TO:	Walpole Conservation Commission	DATE:	1-21-21
FROM:	Katie Enright, PE	HSH PROJECT NO.:	19097
SUBJECT:	55 Summer Street, Proposed chain link fence

Proposed Fence Extension

PERIMETER FENCE DETAIL
NOT TO SCALE

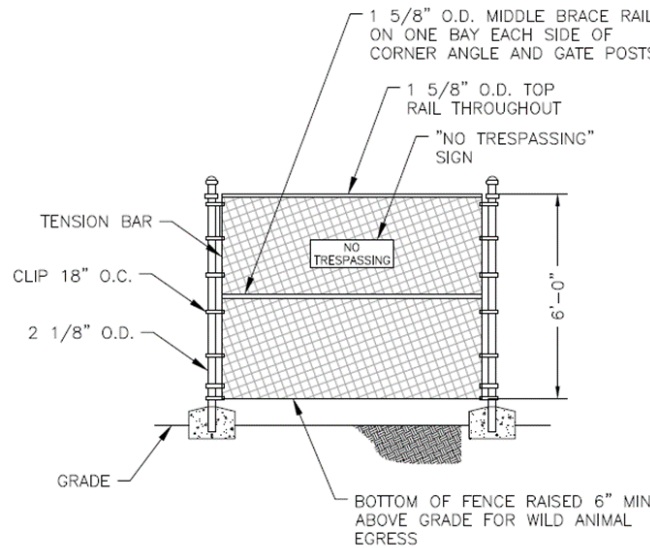
The Walpole Zoning Board of Appeals has requested that the Design Team for Cedar Crossing request a continuous fence along the railroad tracks long the eastern project boundary. Previously the design plan called for a continuous fence except where the fence would be located within a 50 ft buffer of an isolated or bordering vegetated wetland. A continuous fence along the tracks would provide 123 feet of chain link fence construction within the isolated vegetated wetland and 14 feet of chain link fence construction within the bordering vegetated wetland with a total fence length of 2,675 linear feet.

The fence, at a 10 ft post separation would account for approximately 14 posts. The fence is proposed to be constructed with a minimum gap of 6" at the bottom of the fence to allow for transmission of small and medium sized animals (raccoon, coyote, skunk, possum, snapping turtle, etc.)

The work to construct this fence would be completed between July and November and it is our opinion that this could be accomplished with de minimus disturbance.
